**REQUEST** Current Zoning: R-3 (single family residential)  
Proposed Zoning: R-12MF(CD) (multi-family residential, conditional)

**LOCATION** Approximately 7.05 acres located on the east side of South Tryon Street, north of Shopton Road West.  
(Council District 3 - Mayfield)

**SUMMARY OF PETITION** The petition proposes to allow up to 72 multi-family residential units on vacant land located to the south of the Rivergate Mixed Use Activity Center.

## PLANNING STAFF REVIEW

### • **Proposed Request Details**

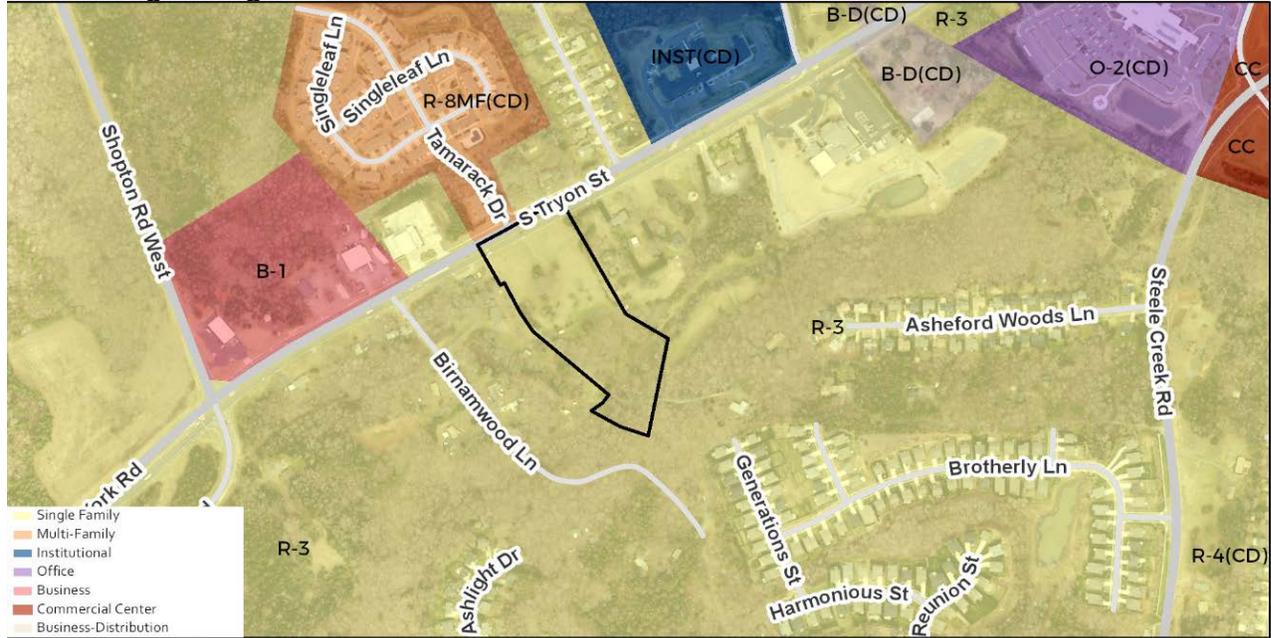
1. Reduce unit count to comply with Steele Creek Area Plan density recommendation of eight dwellings per acre. **Not addressed.**
2. Provide a buffer/fence for the single family residential property located to the southwest of the subject site. **Not addressed.**

3. ~~The petitioner should revise the site plan to show Public Street A 71' right-of-way extending to the southern property line and construction a future connection to existing Generation Street.~~ **Addressed.**
4. ~~The petitioner should revise the site plan to show Public Street B with parallel parking. If angled parking is desired, must be reverse angle with 14' wide travel lane adjacent to the angle parking and 10' wide travel lane adjacent to the parallel parking (total 24' travel width). Reverse parking stall depth is 18' (measured perpendicular to the curb), stall width is 10.5' (measured parallel to travel lane).~~ **Addressed.**

5. ~~Site is in a wedge and will be required to provide 15% tree save area based on gross acreage. 15% of 7.05 acres = 1.05 acres tree save. Show tree save and calculations area on site plan. Tree save must contain existing healthy tree canopy. Tree save must be 30 feet width minimum.~~ **Addressed.**
